Futaba T4PX/T4PXR ソフトウェアアップデート変更内容 (バージョン 1.3)

Futaba T4PX/T4PXR SOFTWARE UPDATE CHANGES (Version: 1.3)

レーシングモード
ON / OFF

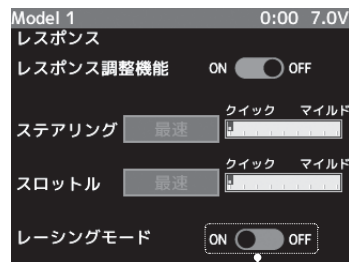
レーシングモード

これまでより、リニアなフィーリングを実現する、レーシングモードを追加しました。

- 1 メニューより [レスポンス] 画面を開きます。
(4PX 取扱説明書 P142 参照)
- 2 「レーシングモード」を [ON] に設定すると、レーシングモードが有効になります。

Racing mode
ON/OFF

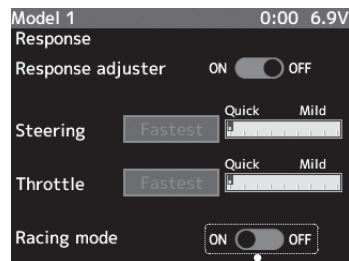
Racing mode

The Racing mode, which improves driving feeling, has been added.

- 1 Open the [Response] menu from the System menu.
(4PX manual P142)
- 2 Turn on the [Racing mode].
